Multibeam Advisory Committee: Recap of investigation into Atlantis EM122 transient depth artifact

Updated 2016-10-26

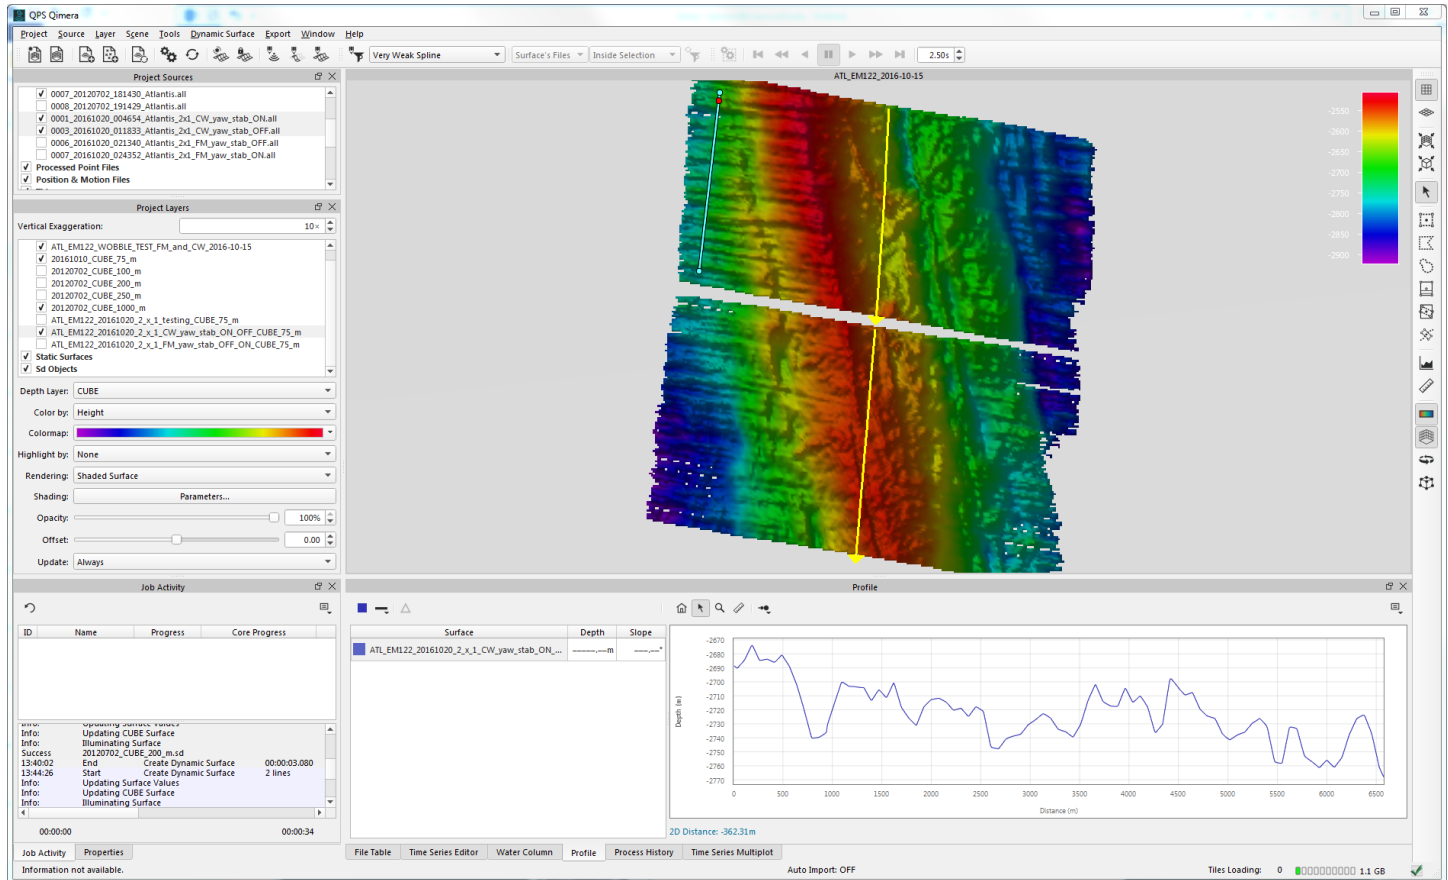
A periodic alternating deep/shallow bias extending across the swath. The surface shown below is illuminated to show the corresponding dark shadows extending across the track while the ship drives approximately south. The amplitude of the bias scales with the angle from nadir, approaching 1% of water depth on the outer beams (depth profile drawn across upper left of surface is shown in lower right window). It appears that the starboard side is generally biased shallower when the port side is deeper, and vice versa.

This artifact appears to exist in data examples going back to 2012. Its amplitude might technically be within spec for this system; however, it is a periodic, non-random bias that complicates processing and visualization. The example below exaggerates the effect visually due to shading.

This is similar to what we might see with an error in the vessel roll data, but the depth artifact does not appear to scale with roll period or amplitude. The artifact comes and goes over the course of many pings and many roll cycles (more discussion below).

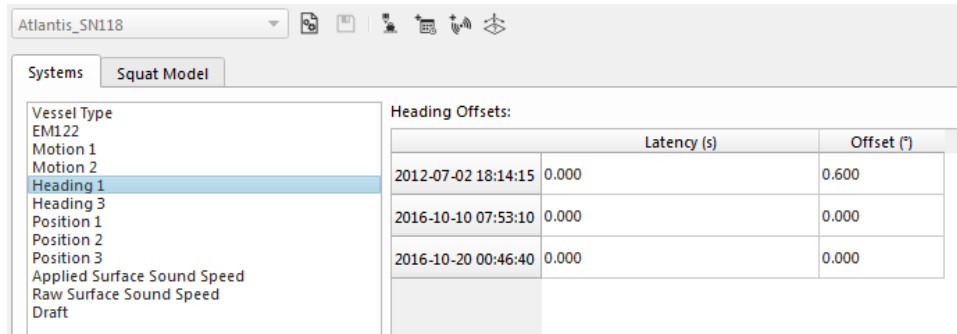
Testing in Qimera shows no improvement when simulating/correcting for motion latency or lever arm offsets in the transducer arrangement. This testing is limited strictly to latency in the arrival of the motion data to the EM122, and lever arms of the motion sensor in the EM122 reference frame. No testing has been done for lever arms of the position feed, and this does not shed any light on possible timing or lever arm issues in the PHINS motion system itself.

In the examples we've examined, the ping interval and period of the vessel motion have typically been within a few seconds of each other. The similar periods of the ping interval and vessel motion could lead to a longer-period modulation of the depth artifact, such as we see in the examples here, if there is an appreciable latency WITHIN the motion system (e.g., during attitude processing, before sending to the EM122, even with negligible latency in the communication to the EM122). This was recently seen on another (non-UNOLS, non-PHINS) vessel which had a nontrivial latency in the MRU processor, 'upstream' from the feed to the EM122. The result of this was a depth artifact with two components:

- i. The first (high-frequency) component is like any other motion error, with a period and amplitude corresponding to the attitude amplitude and latency. This would appear similar to a latency in the 'downstream' communication between the motion sensor and EM122. Note: this is also the same kind of communication latency that can be simulated/corrected in Qimera, and has not addressed the depth artifact coming and going over many ping cycles.

- ii. The second (low-frequency) component is due to the small difference between the ping interval and attitude period. The difference between the true attitude and applied attitude changes slightly with each ping, leading to a modulation of the depth artifact over the course of many ping cycles (e.g., 60-90 seconds). This is more in line with the kind of artifact we see, which has not been addressed by simulating/correcting motion communication latency in Qimera.
